<b>Title - Sujet</b> Fire Protection Repairs	
<b>Solicitation No. - N° de l'invitation</b> F1571-175061/A	<b>Amendment No. - N° modif.</b> 001
<b>Client Reference No. - N° de référence du client</b> F1571-175061	<b>Date</b> 2017-11-30
<b>GETS Reference No. - N° de référence de SEAG</b> PW-\$PWY-020-8230	
<b>File No. - N° de dossier</b> PWY-7-40261 (020)	<b>CCC No./N° CCC - FMS No./N° VME</b>
<b>Solicitation Closes - L'invitation prend fin</b> <b>at - à 02:00 PM</b> <b>on - le 2017-12-06</b>	
<b>Time Zone</b> Fuseau horaire Pacific Standard Time PST	
<b>F.O.B. - F.A.B.</b> <b>Plant-Usine:</b> <input type="checkbox"/> <b>Destination:</b> <input checked="" type="checkbox"/> <b>Other-Autre:</b> <input type="checkbox"/>	
<b>Address Enquiries to: - Adresser toutes questions à:</b> Ly, Ronny(PWY)	<b>Buyer Id - Id de l'acheteur</b> pwy020
<b>Telephone No. - N° de téléphone</b> (604) 318-5750 ( )	<b>FAX No. - N° de FAX</b> (604) 775-6633

<b>Destination - of Goods, Services, and Construction:</b> <b>Destination - des biens, services et construction:</b> DFO - Port Edward Harbour - Port Edward, BC

## **Port Edward – Fire Protection Repairs Addendum #1**

Supply and install new sprinkler heads

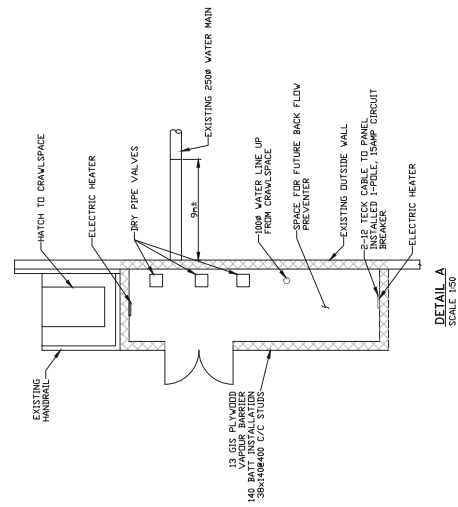
- 1. The items 1.8.2.1.2, 1.8.2.3.2, 1.8.4.1.2, 1.8.4.2.2, and 1.8.4.3.2 “Supply and install new sprinkler heads” is revised in section 01 11 00 “Summary of Work,” to read as follows,**

- Supply and install the following sprinkler head, or owner approved equivalent.
    - Victaulic Firelock Model V2703, Commercial Storage, K 5.6, Upright, Standard Response, 200°F, Approval class cULus, FM, VDS, LPCB, CE, CCCF, Brass 250psi / 17 bar.
  - Sprinklers installed in-line at 3.1m (10') spacing with Victaulic mounts.
- 2. The reference drawing 703411 “Port Edward, BC – Buildings New Fire Exits – Floor Plans – Buildings 1001, 1002, &1003 / Buildings 1004 & 1005” to be replaced with the following drawing,**
